SINCLAIR hille architects

Addendum #3

Project Name:	Concordia STEM Seward, NE
Project No.:	16022-05
Date Issued:	May 11, 2018
Bid Date:	Thursday, May 17, 2018

1 Main Level Power Plan – Area A.1
1/4" = 1'-0"

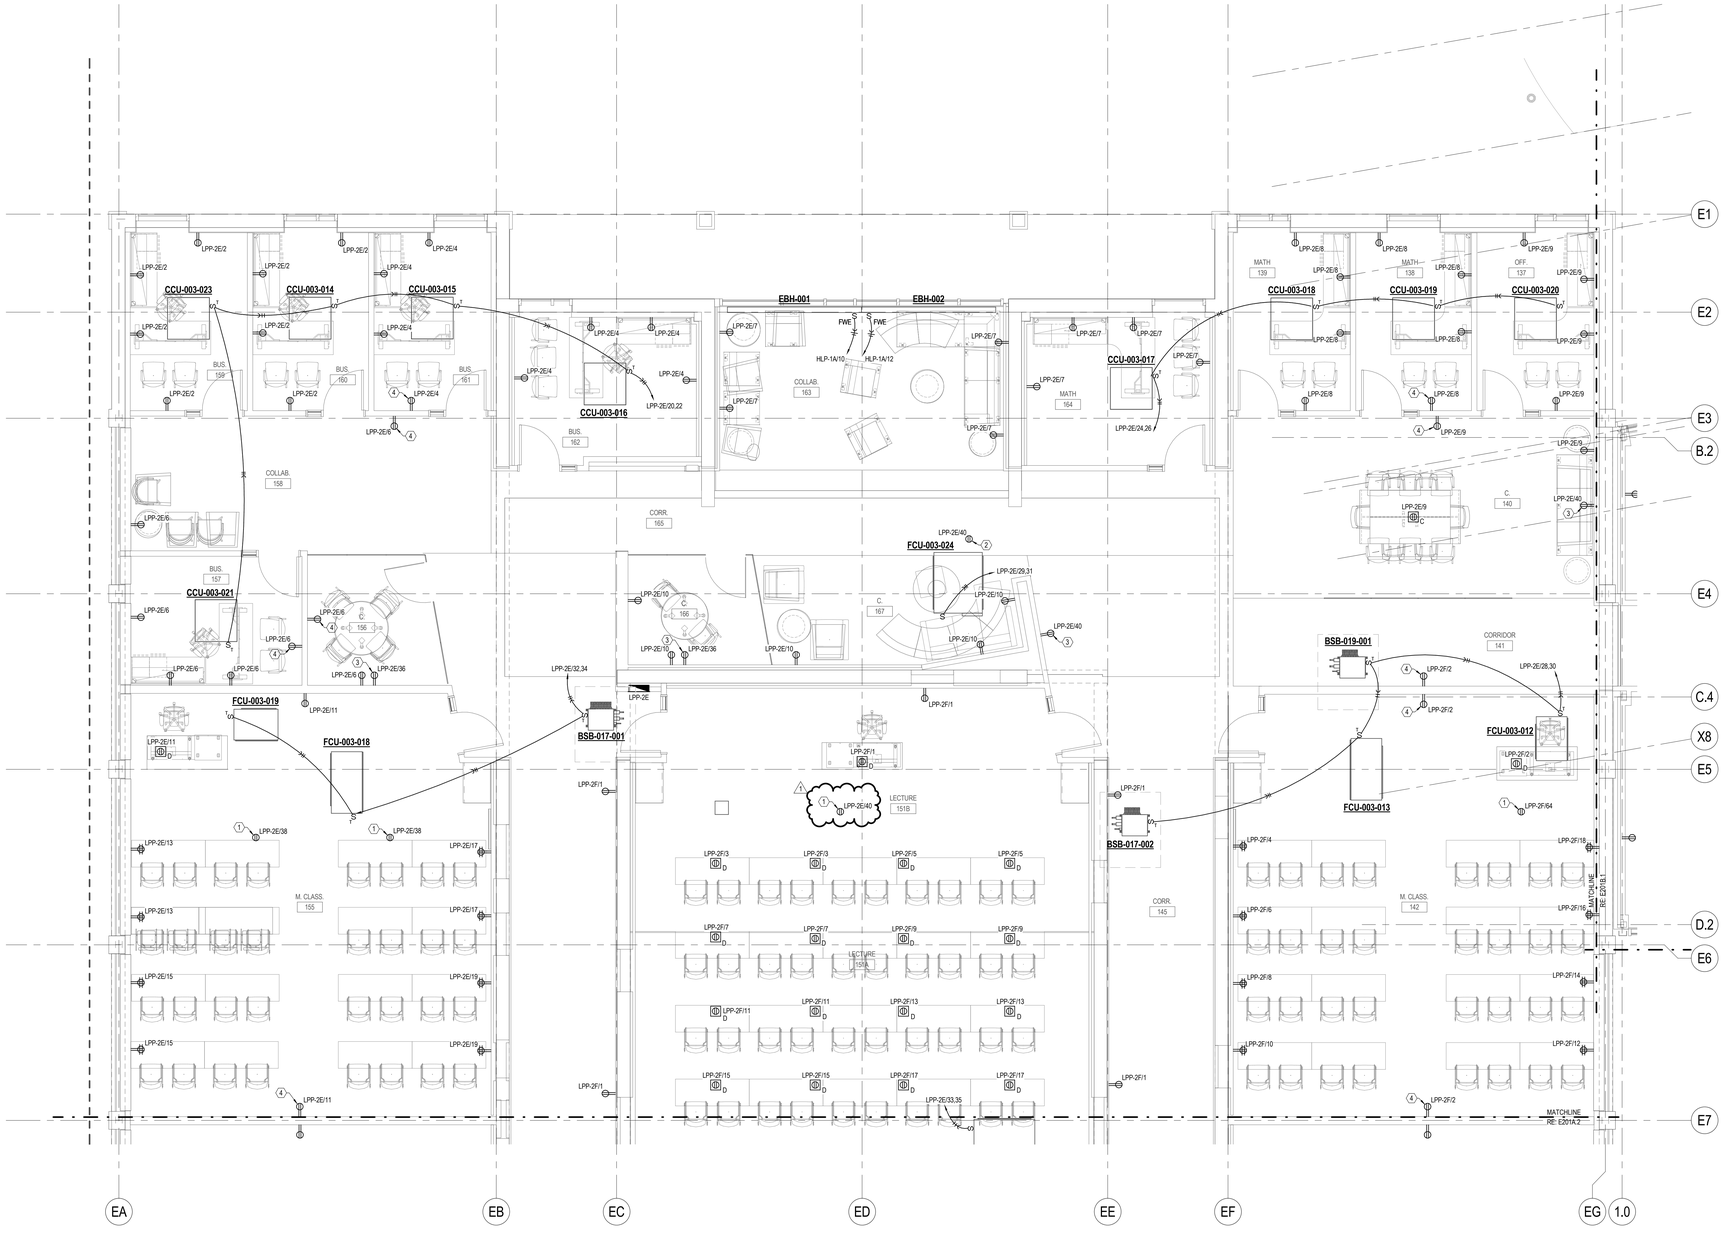
ADD 3-34. Drawing E201A.1. Provide ceiling mounted receptacle (LPP-2E/40) for ceiling mounted projector in Lecture 151A. See drawing T101A for projector location.

1 Main Level Power Plan – Area B.1
1/4" = 1'-0"

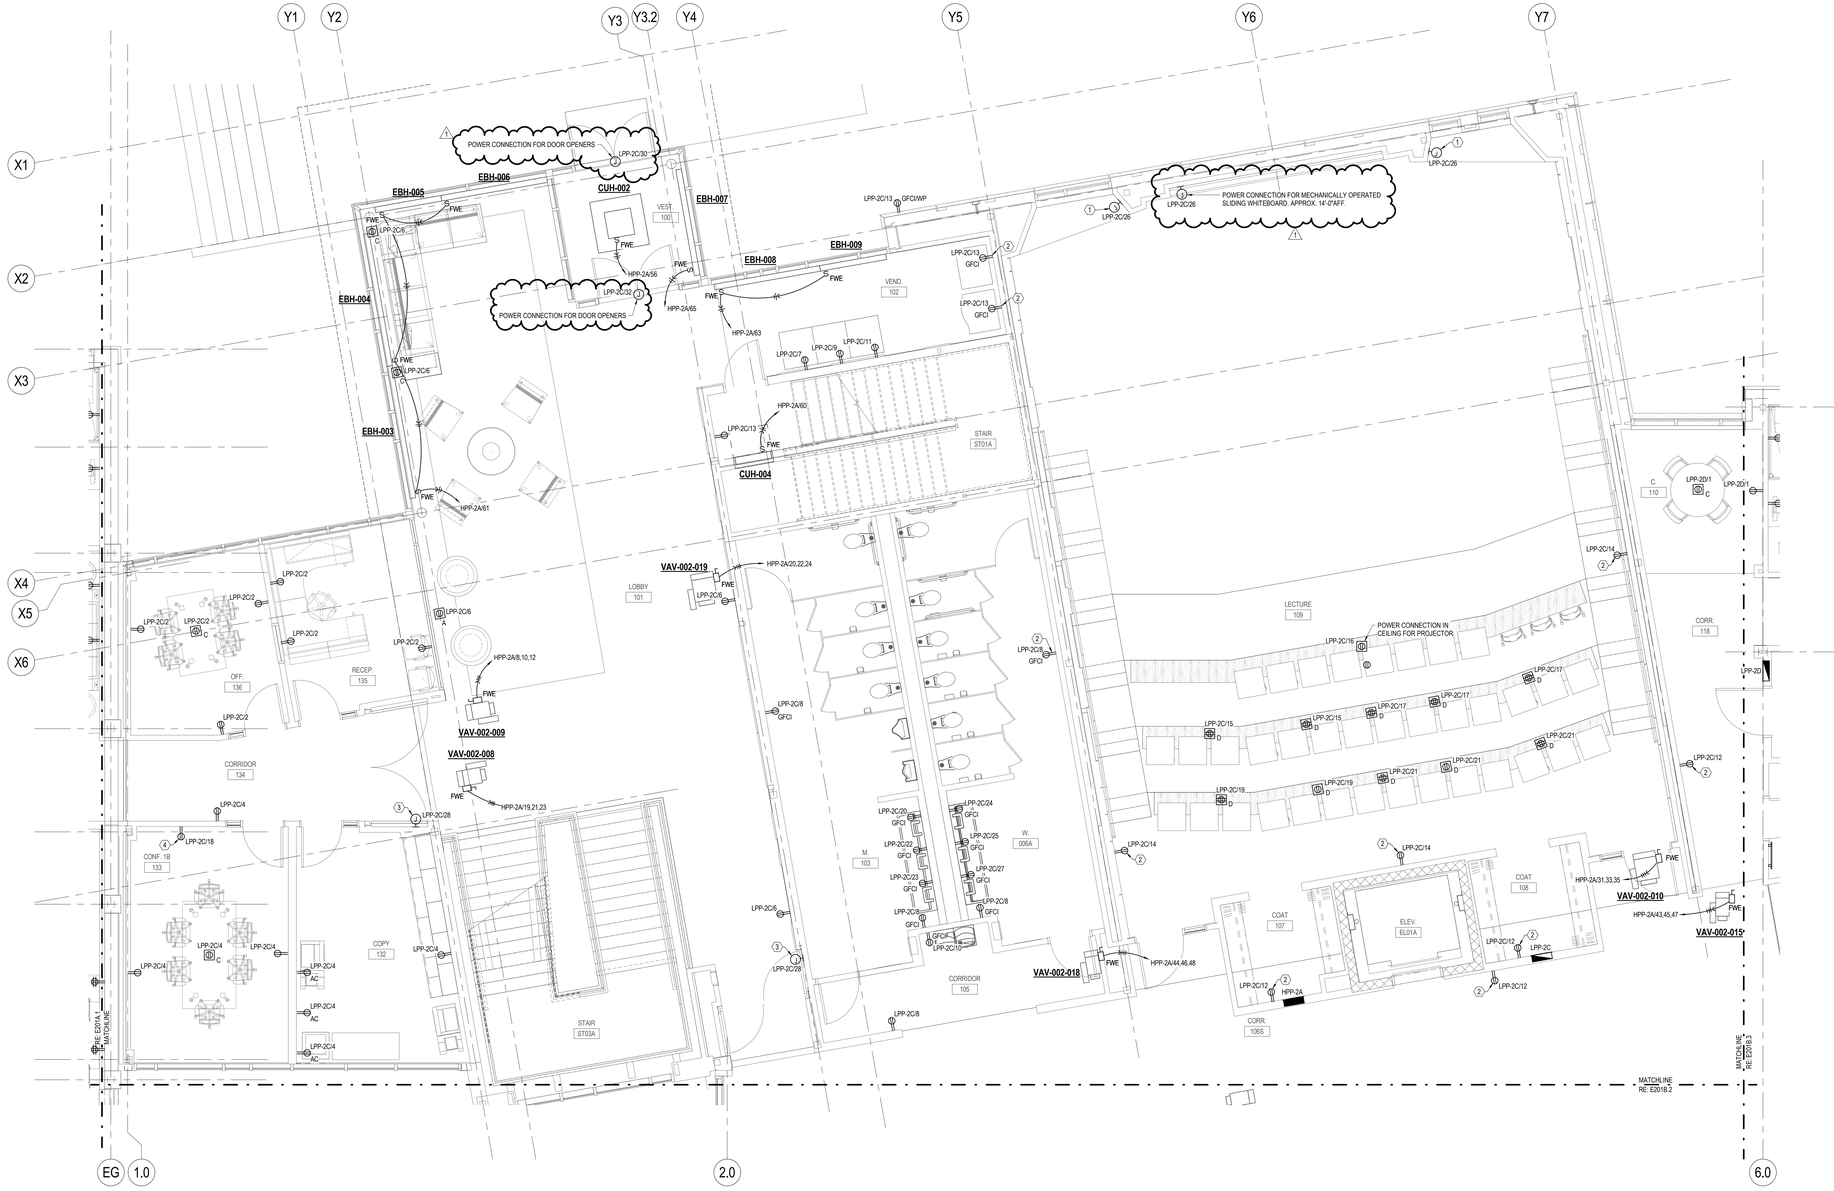
ADD 3-35. Drawing E201B.1. Power connection was added for mechanically operated sliding whiteboard. Power was added for powered door openers in Vestibule 100.

1 Roof Level Power Plan – Area A.2
1/4" = 1'-0"

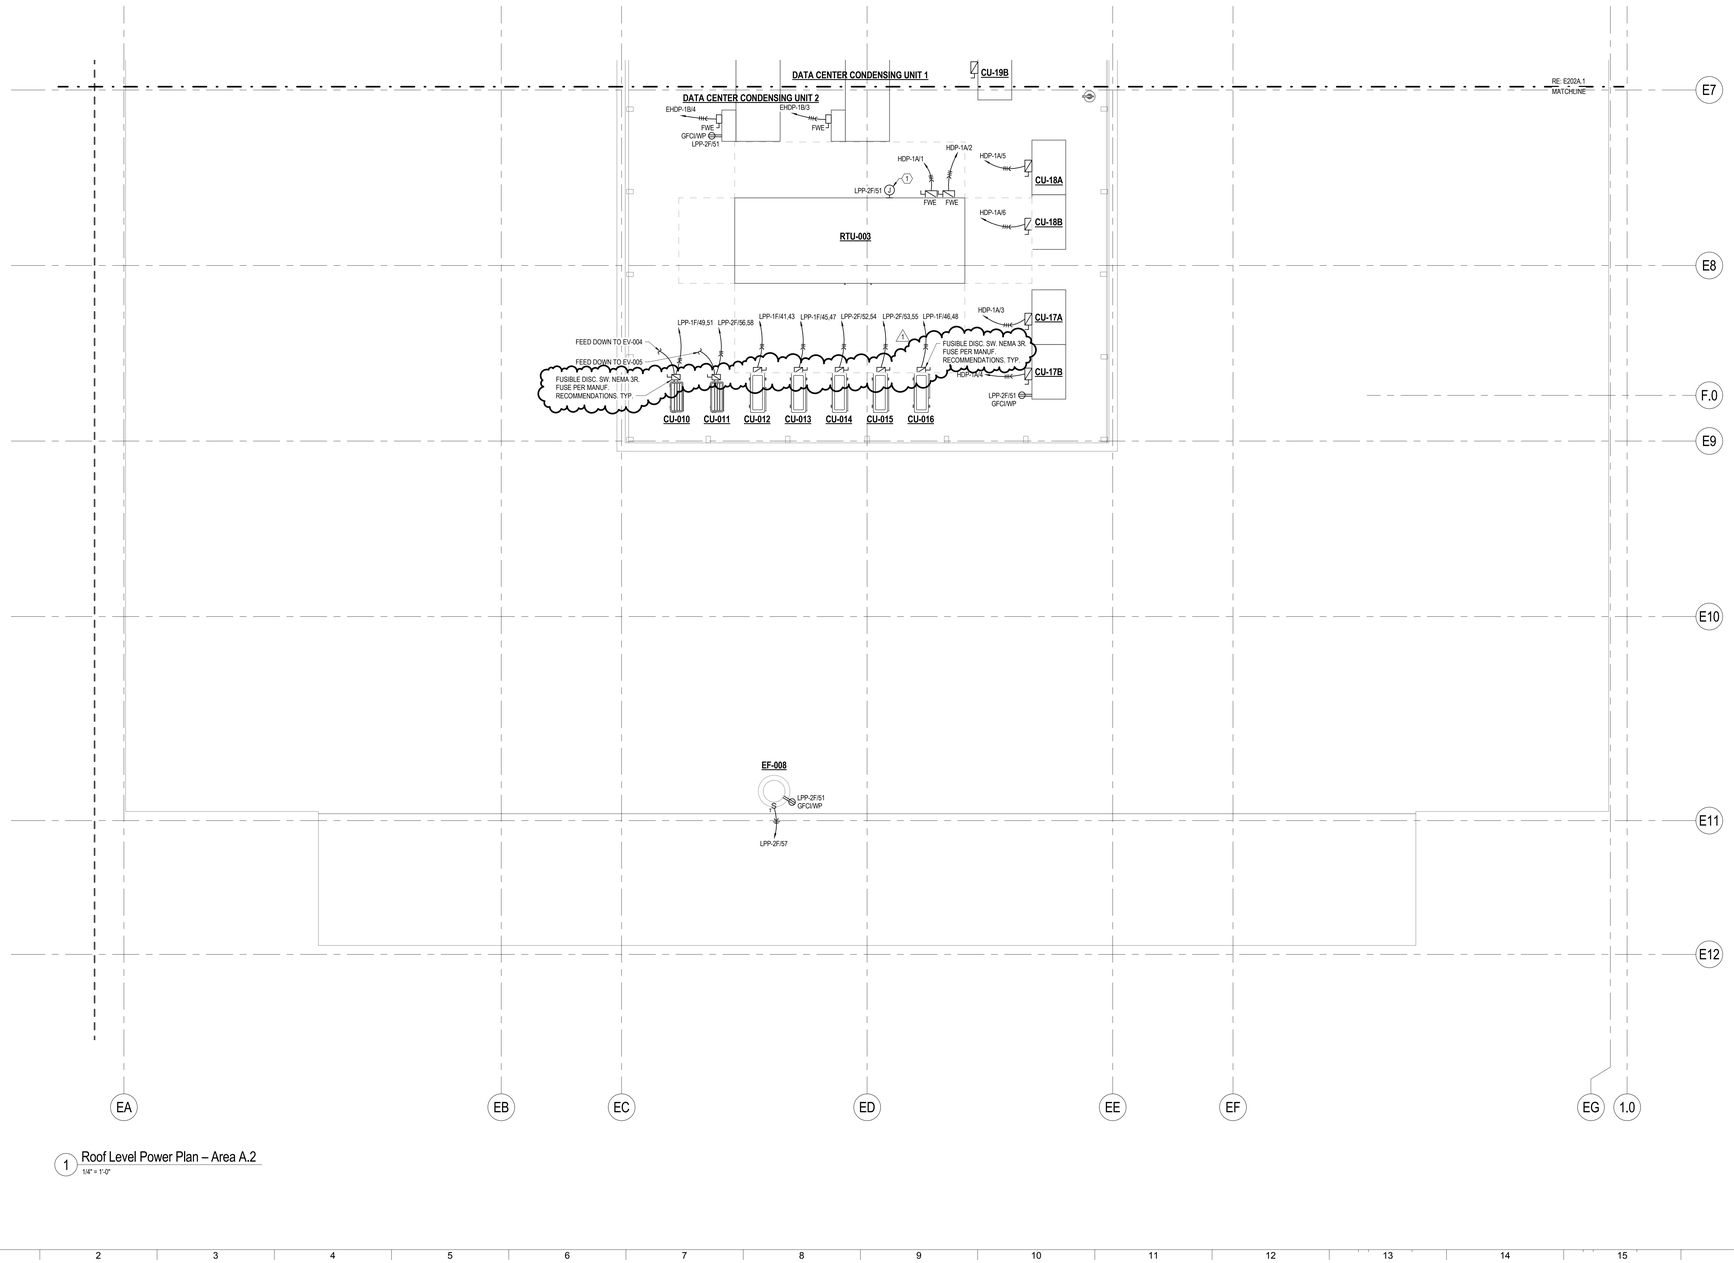
ADD 3-36. Drawing E202A.2. Provide a fusible disconnect switch (NEMA 3R Housing) for condensing units CU-012, CU-013, CU014, CU-015, and CU-016 instead of a non-fusible disconnect switch. Fuse Switch per manufacturer's recommendation.

ADD 3-37. Drawing E202A.2 CU-010, and CU-011. Disconnect switch shall have NEMA 3R housing. Fuse switch as recommended by manufacturer.

1 Roof Level Power Plan – Area B.3
1/4" = 1'-0"

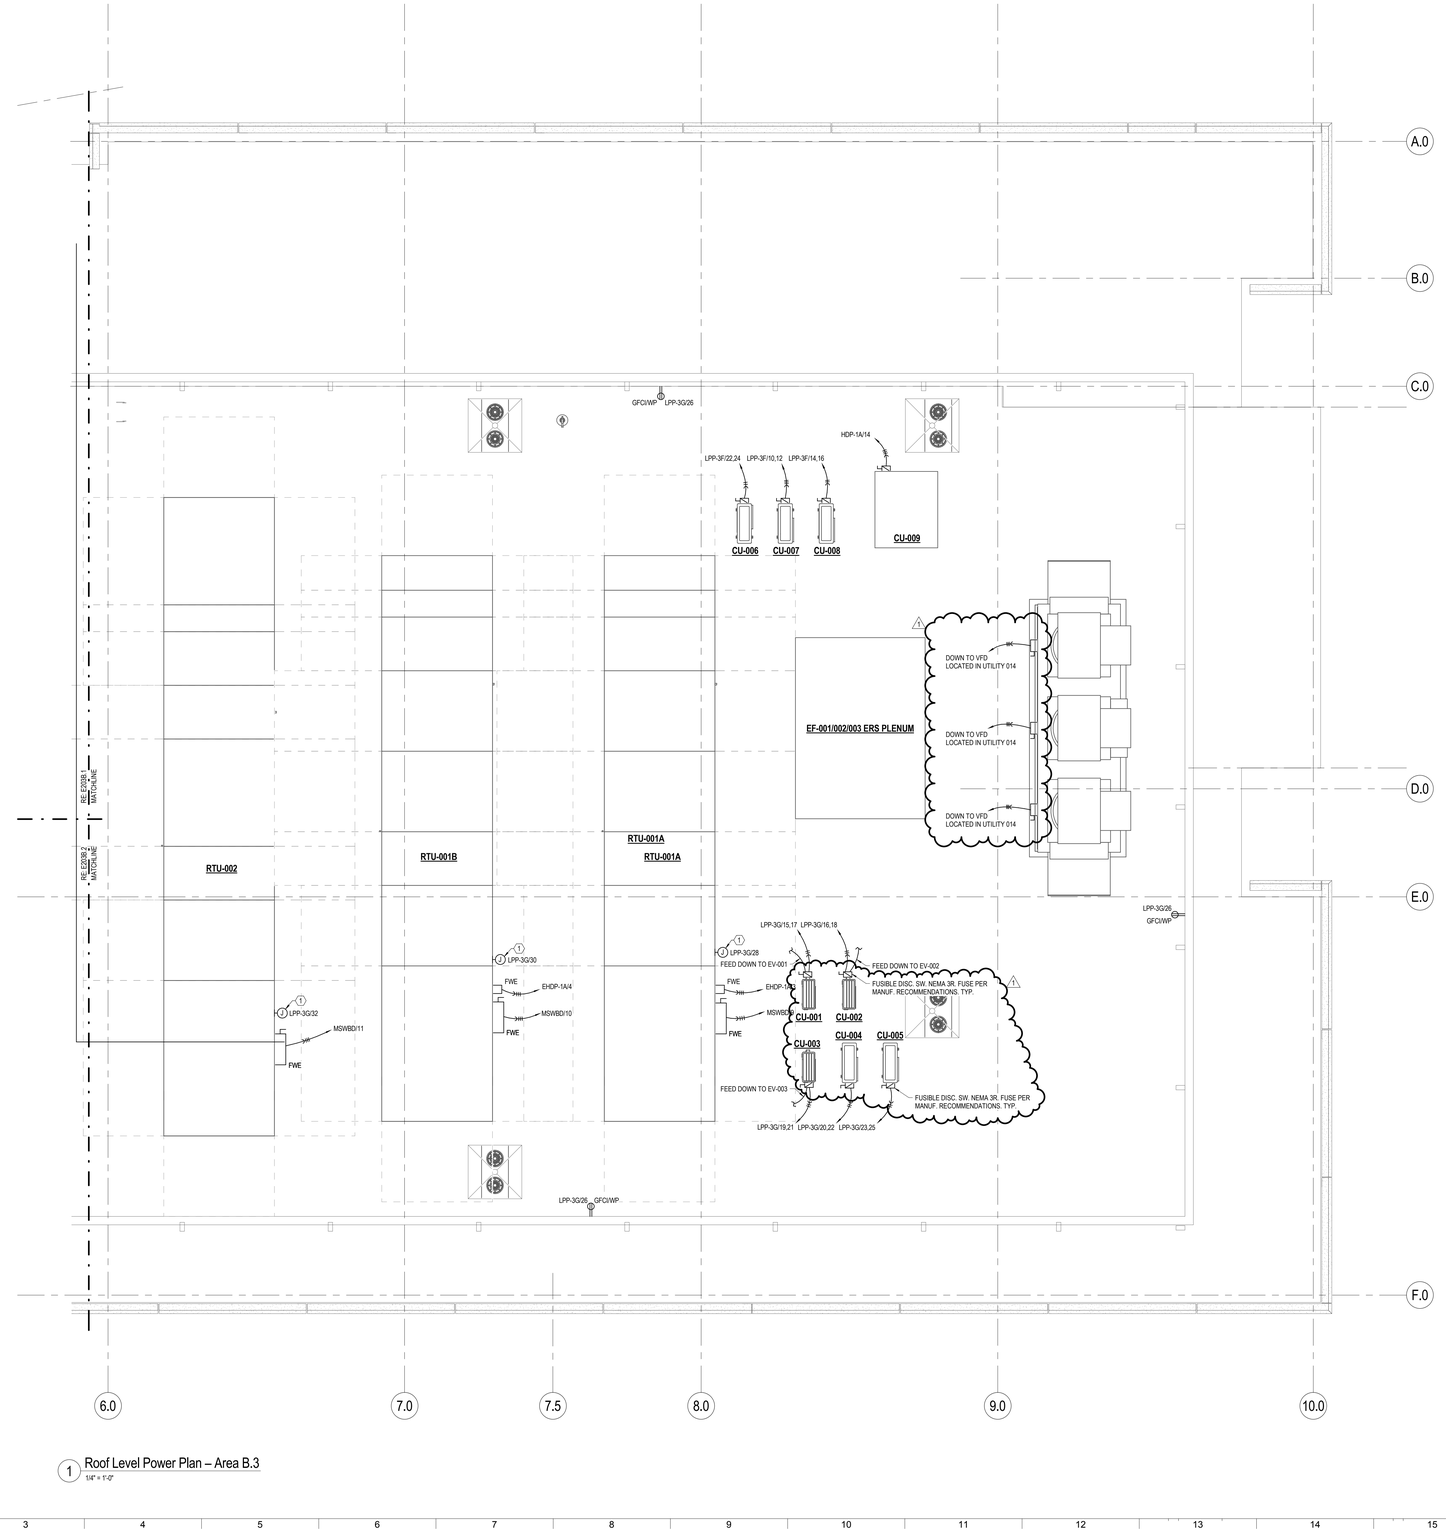
ADD 3-38. Drawing E203B.3 CU-001, CU-002, and CU-003. Disconnect switch shall have NEMA 3R housing. Fuse switch as recommended by manufacturer.

ADD 3-39. Drawing E203B.3. Provide a fusible disconnect switch (NEMA 3R Housing) for condensing units CU-004, CU-005, CU006, CU-007, and CU-008 instead of a non-fusible disconnect switch. Fuse Switch per manufacturer's recommendation.

1 TECHNOLOGY - LOWER LEVEL FLOOR PLAN - AREA A

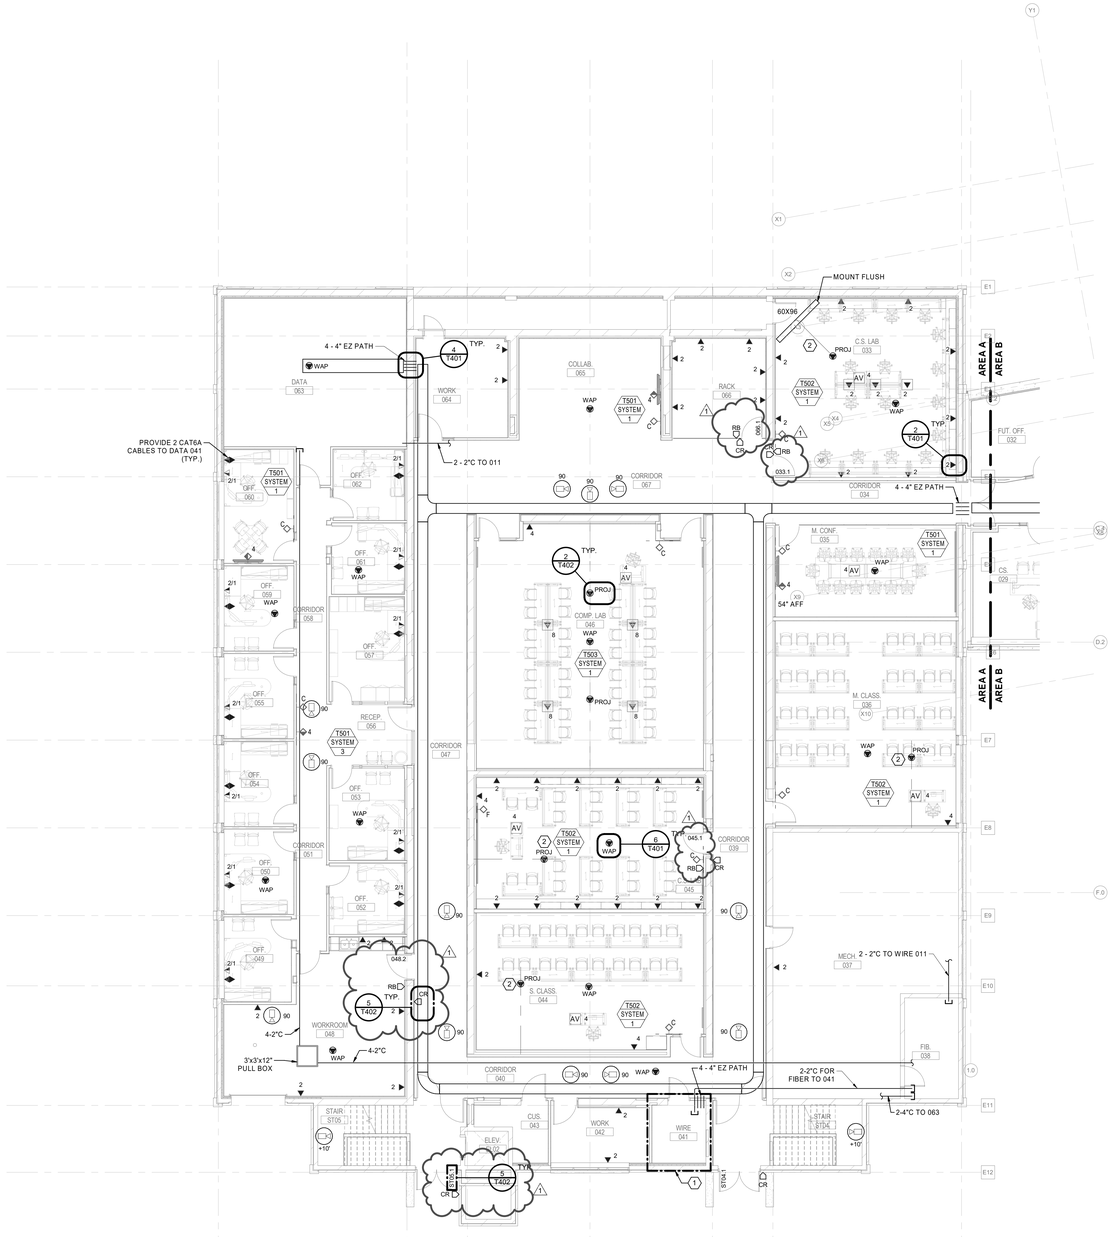
- Added Single Door Detail Callout
- Added Double Door Detail Callout
- Added Request-to-Exit Button to Door 048.2
- Added Request-to-Exit Button to Door 045.1
- Added Request-to-Exit Button to Door 066.1
- Added Request-to-Exit Button to Door 033.1
